Issue	Date	Des'n	Dr'n	Chkd	App'd	Description
P1	AUG. 2017	-	-	-	-	PRELIMINARY DESIGN - FOR REVIEW

GREATER VANCOUVER SEWERAGE AND DRAINAGE DISTRICT LIQUID WASTE SERVICES SAPPERTON CONNECTION McNEELY CHAMBER CHAMBER DETAIL		SCALE: AS NOTED DISTRICT FILE ##-### DRAWING NUMBER SHEET 5
Design: P.L. Drawn: M.W. Checked: _____ INT. Approved _____ INT. Manager _____	SUPERSEDES PRINTS OF THIS DRAWING NUMBER WITH LETTERS PREVIOUS TO P1

PLAN
1:50

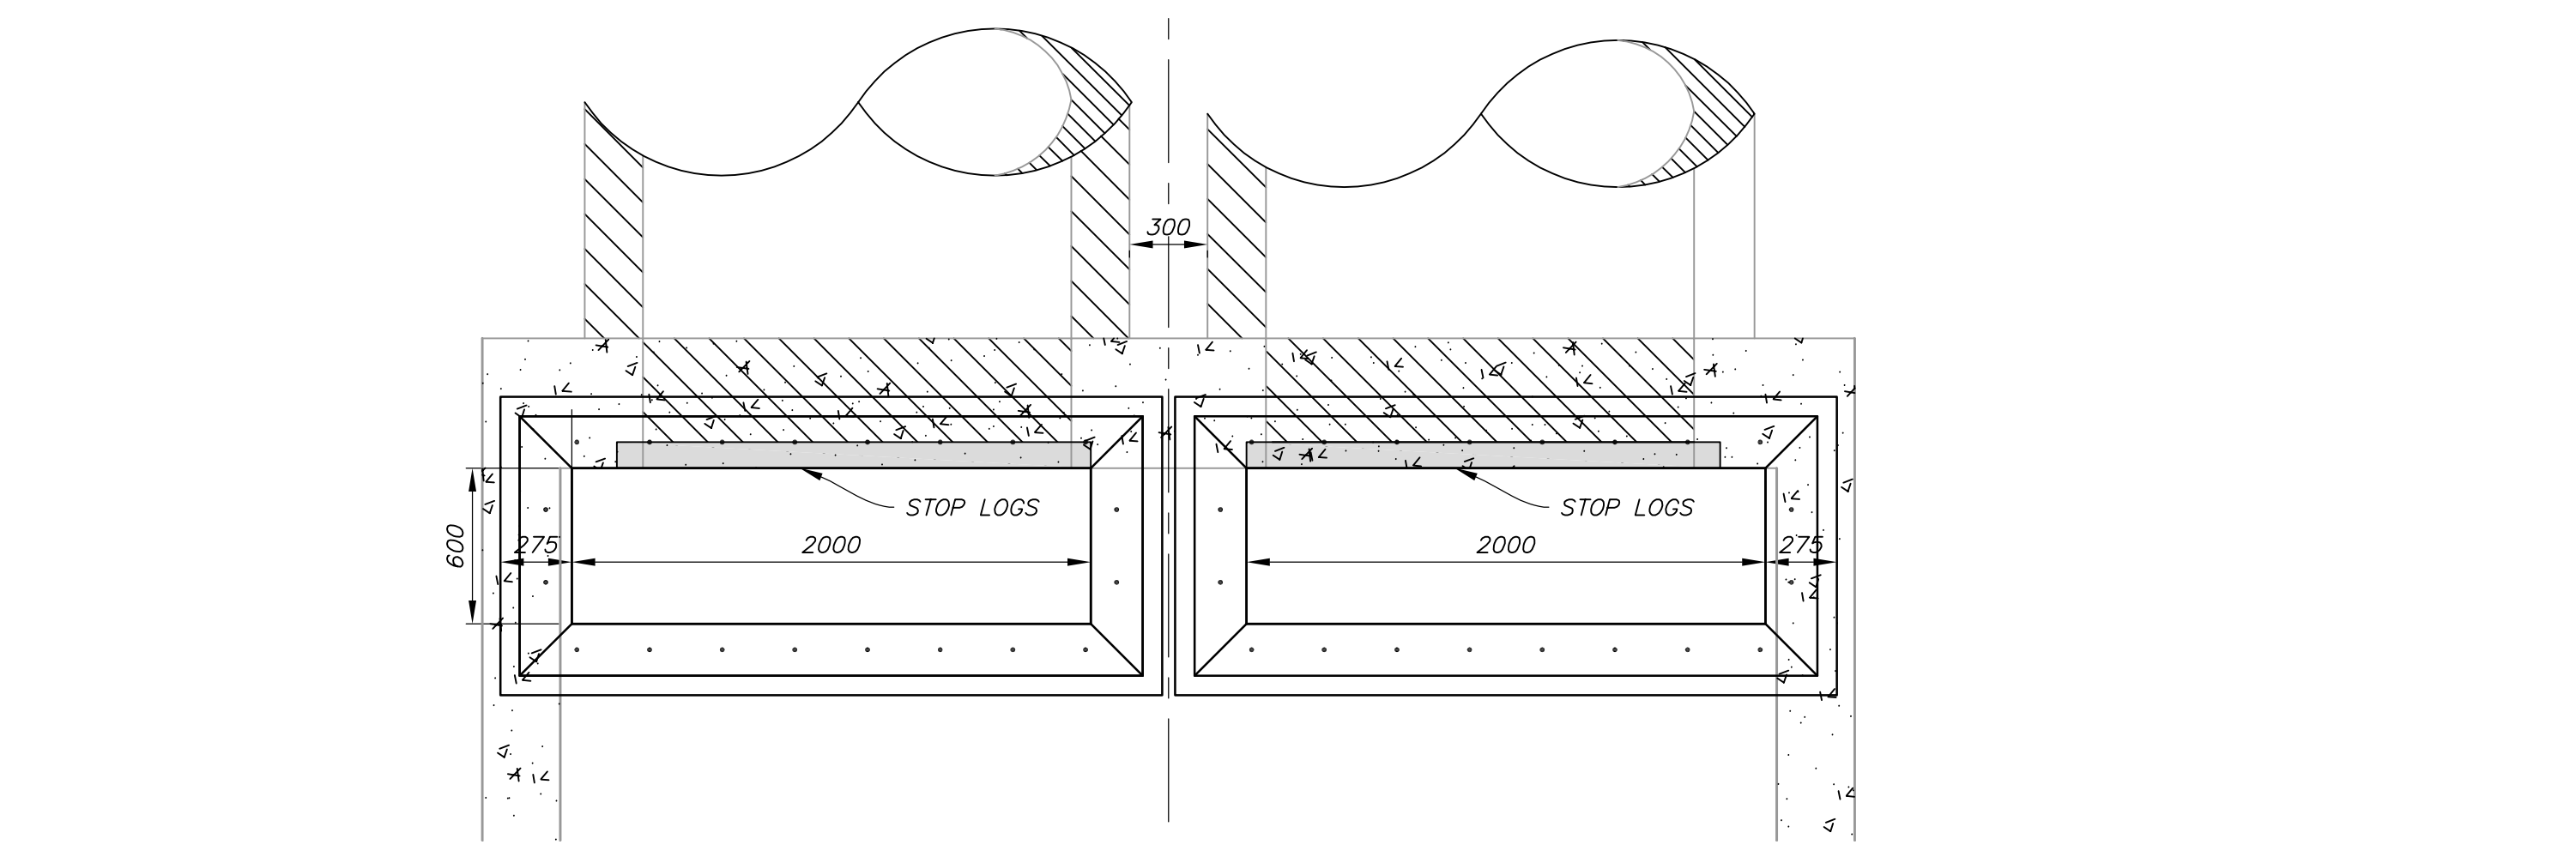
How long should this nose be?

What is a good taper ratio for the nose?

Is there a formula for calculating a suitable transition length here? I.e. I need a taper ratio for the expansion from 1 pipe to 2 pipes.

What should the curvature be? I.e. radius.

What should be the minimum distance here?
